FINAL ENVIRONMENTAL IMPACT STATEMENT

RELOCATION OF THE 146th TACTICAL AIRLIFT WING OF THE CALIFORNIA AIR NATIONAL GUARD

VOLUME III COMMENTS AND RESPONSES

AUGUST 1985

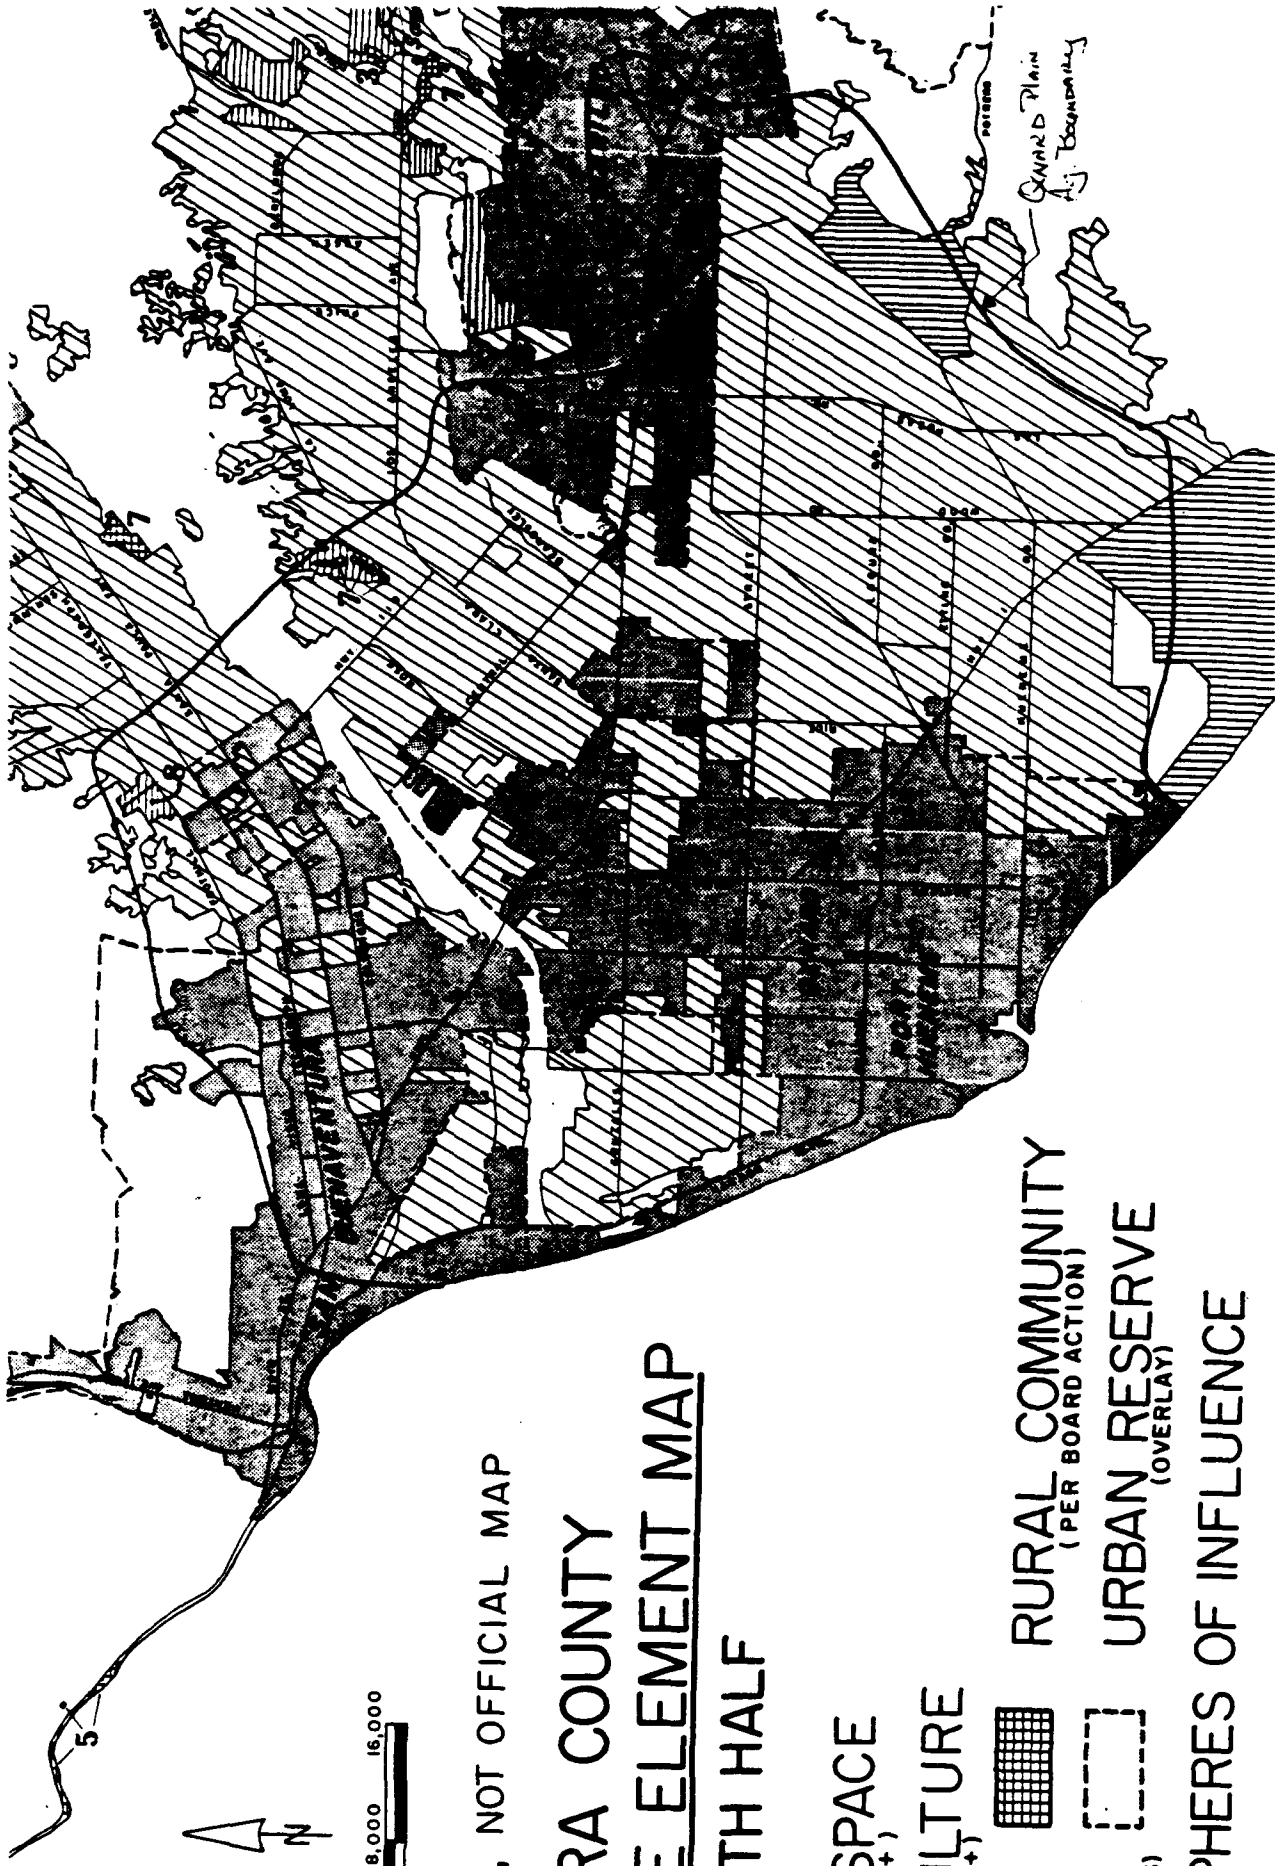
For purposes of assessment of cumulative effects, the EIS should address the withdrawal of all 219 acres, rather than the 210 figure allegedly under cultivation.

RECOMMENDATIONS TO AVOID HIGH CONFLICT AREAS

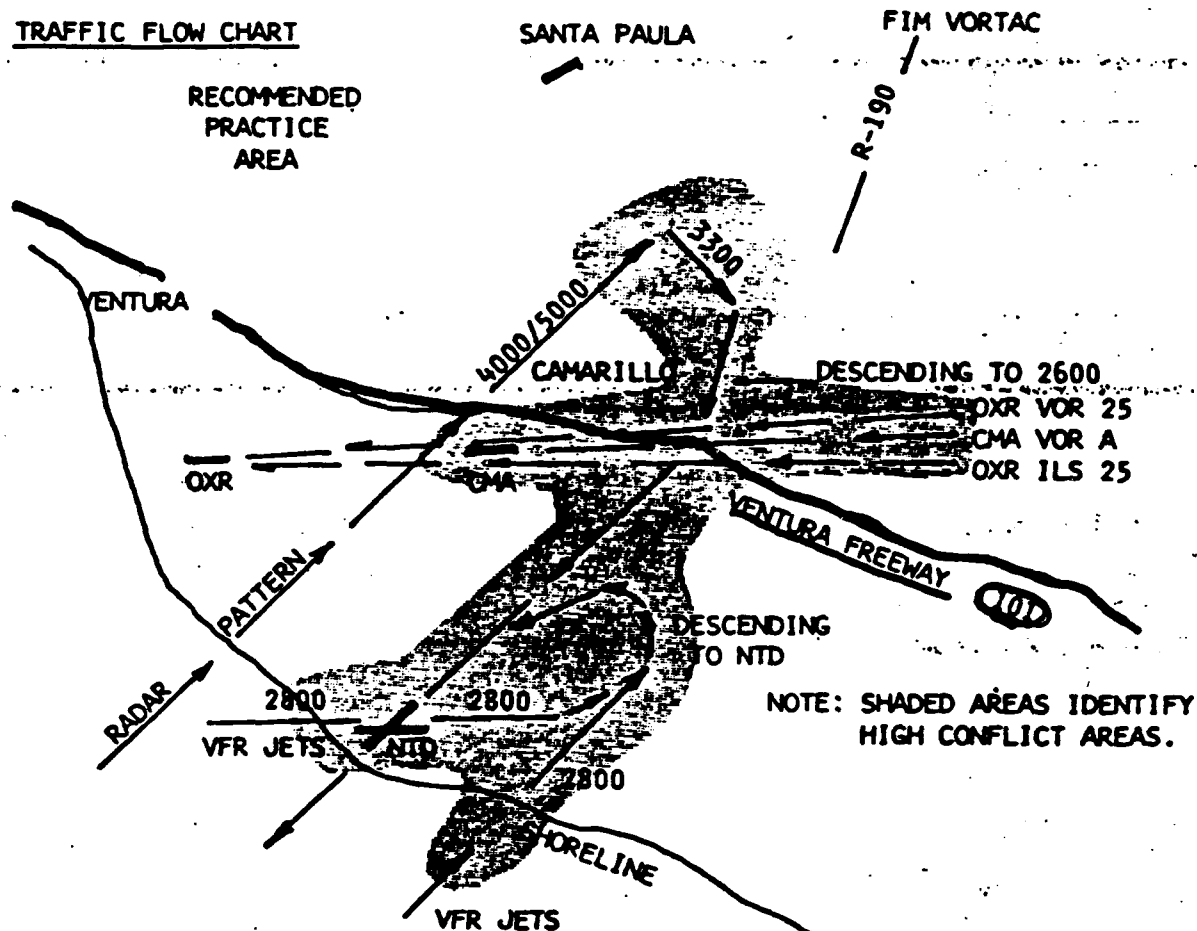
Shoreline Eastbound. Departing OXR turn left to remain north of Mugu RWY 27, cross Mugu at or above 3,000' to clear R-2520 and jet arrivals. Departing CMA turn right off RWY 26, climbing right turn back over the airport then to the shoreline staying at 3,000' or below until clear of radar pattern west of the CMA Airport. Then climb on course south-eastbound.

Ventura Freeway Eastbound. Departing OXR/CMA turn right northbound until in the vicinity of Los Angeles Avenue (the first major paved two-lane road north of the foothills, running East and West). Then proceed eastbound at or below 2,500 feet until east of the Fillmore 190 radial.

RECOMMENDATIONS TO AVOID HIGH CONFLICT AREAS

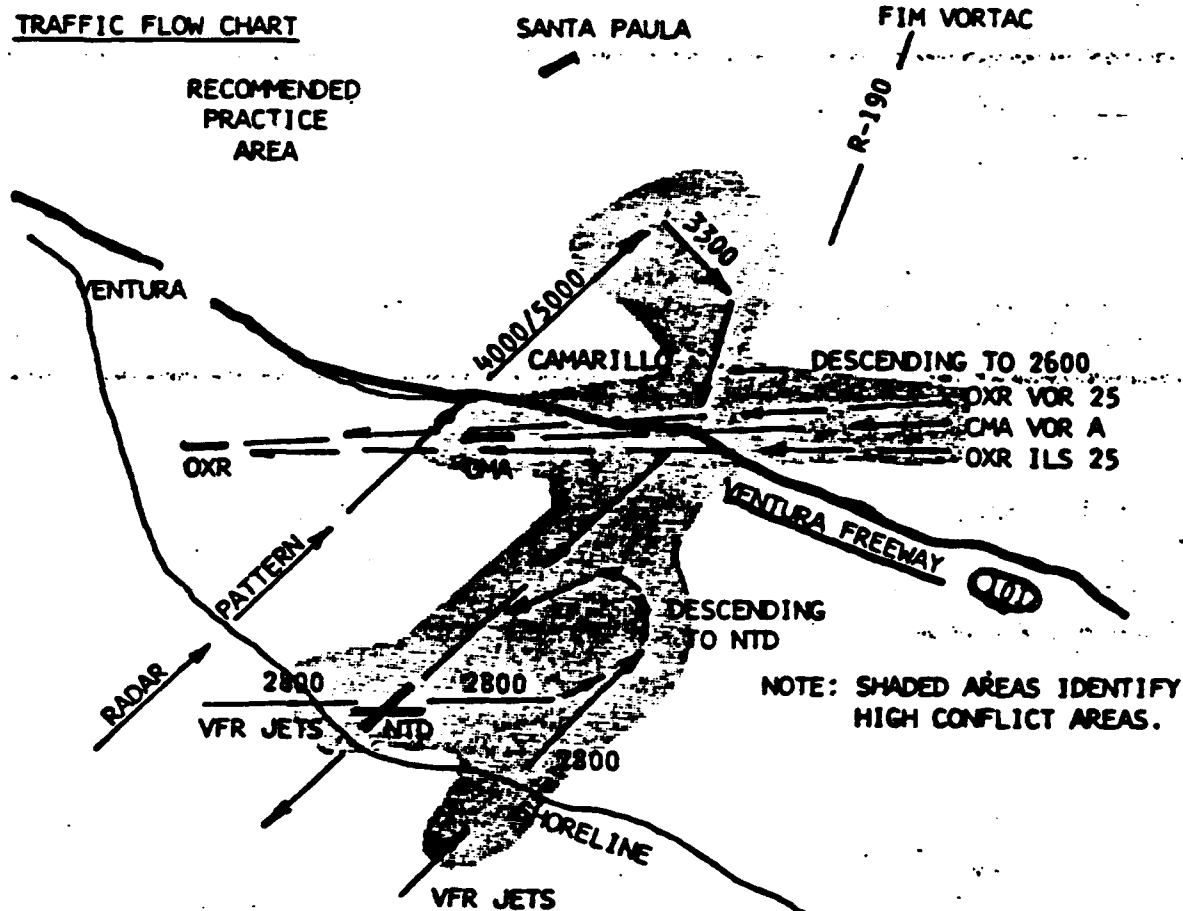
Shoreline Eastbound. Departing OXR turn left to remain north of Mugu RWY 27, cross Mugu at or above 3,000' to clear R-2520 and jet arrivals. Departing CMA turn right off RWY 26, climbing right turn back over the airport then to the shoreline staying at 3,000' or below until clear of radar pattern west of the CMA Airport. Then climb on course south-eastbound.

Ventura Freeway Eastbound. Departing OXR/CMA turn right northbound until in the vicinity of Los Angeles Avenue (the first major paved two-lane road north of the foothills, running East and West). Then proceed eastbound at or below 2,500 feet until east of the Fillmore 190 radial.

RECOMMENDATIONS TO AVOID HIGH CONFLICT AREAS

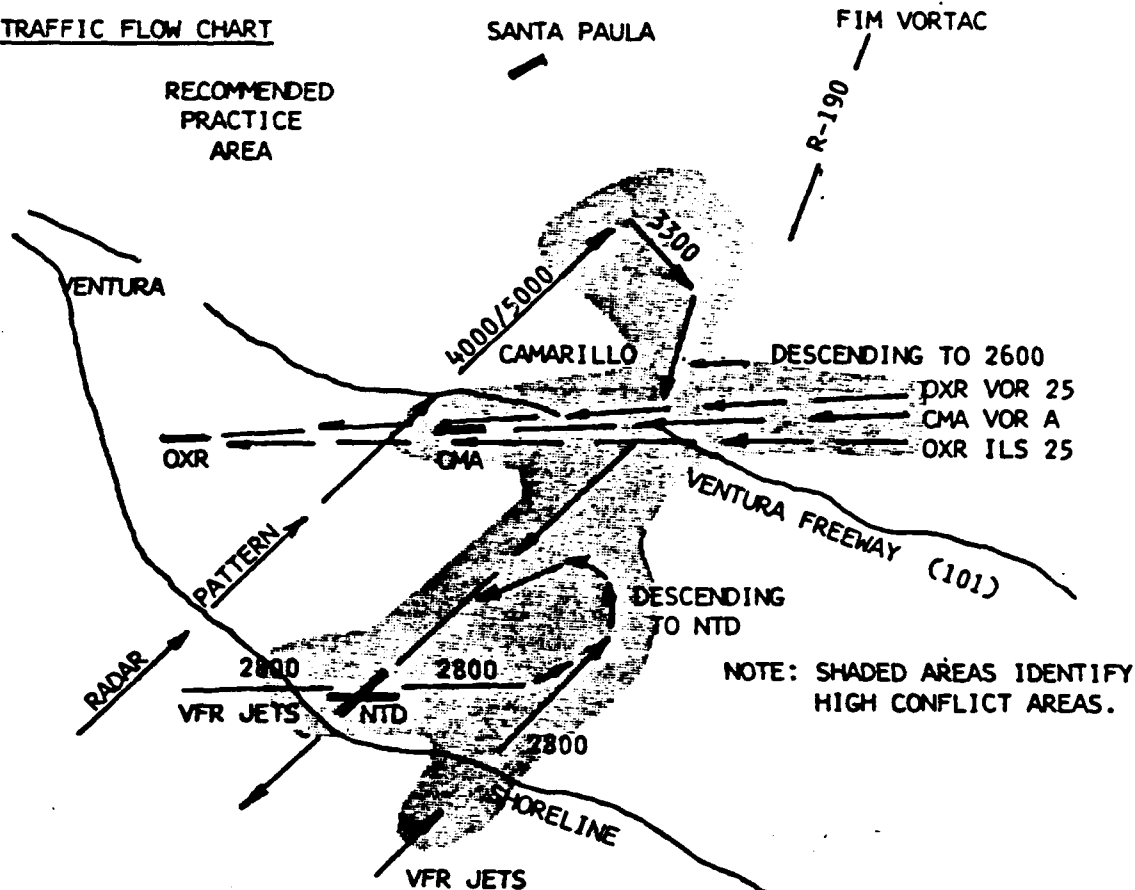
Shoreline Eastbound. Departing OXR turn left to remain north of Mugu RWY 27, cross Mugu at or above 3,000' to clear R-2520 and jet arrivals. Departing CMA turn right off RWY 26, climbing right turn back over the airport then to the shoreline staying at 3,000' or below until clear of radar pattern west of the CMA Airport. Then climb on course south-eastbound.

Ventura Freeway Eastbound. Departing OXR/CMA turn right northbound until in the vicinity of Los Angeles Avenue (the first major paved two-lane road north of the foothills, running East and West). Then proceed eastbound at or below 2,500 feet until east of the Fillmore 190 radial.
